**RC10
B6.2
TEAM KIT**

**RC10
B6.3
TEAM KIT**

RC10B6.2 vs. RC10B6.3 Comparison

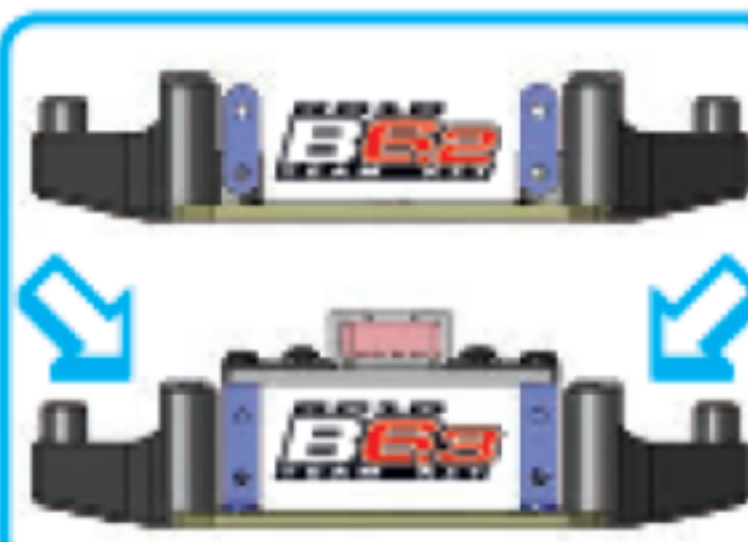
New wide pivot C arm mount

New wide pivot D arm mount

New +4mm shock rod ends included

New front shock lower and plastic cover

New rear shock lower and plastic cover

Octalock Spur and premium LCF material slipper pads (#000329 = 11mm ID, #000330 = 10mm ID)

2.5mm vs 2mm thickness shock plates

Updated wing mount

New molded wire clips

Side rails updated for new servo mount

New servo mount with integrated transponder mount

New holes added to chassis for servo mount

Keyed top plate to steering bellcrank brace

New material steering linkage rod ends

Hardware for tie-rod battery brace included

Carbon fiber +1 steering plates
